TITLE: Branches Clone with ATmega328 (Arduino Nano)		REV: 1.3
嘉立创EDA	Company: Sourcery Studios - MiaW	Sheet: 1/1
	Date: 2022-12-28	Drawn By: Kristian Blå sol

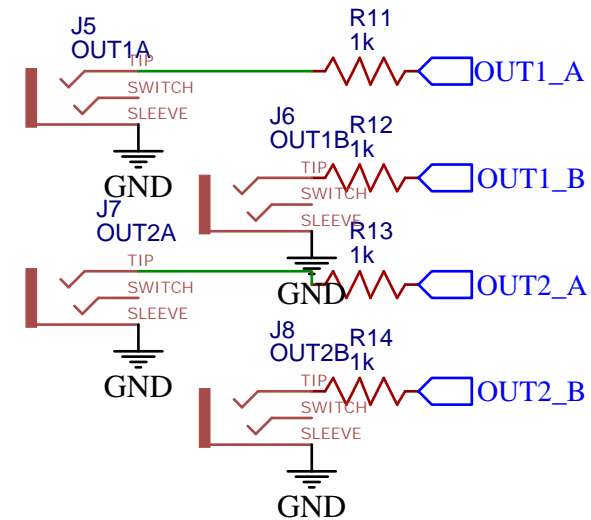
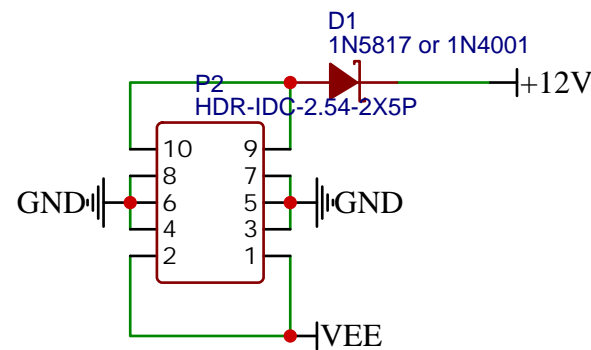
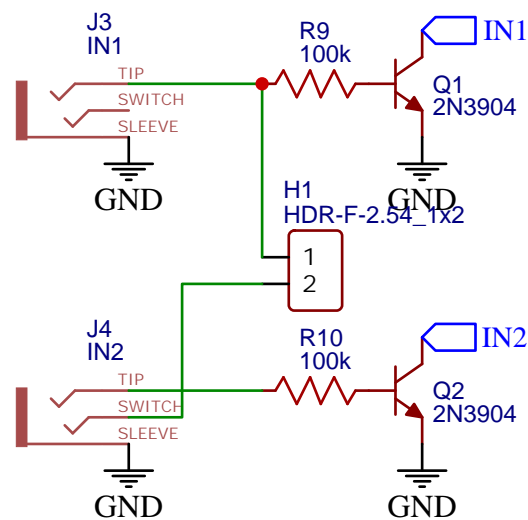
v1.1 Fixed frontpanel height to 128.5 and ch2 nc to ch1 input, fixed zener diode name
v1.2 removed the pots and renamed the zener diode and changed R15 to 1k5
v1.3 added 100k on the pot instead of the trimpot. Removed the 470nF Dont know where it came from?
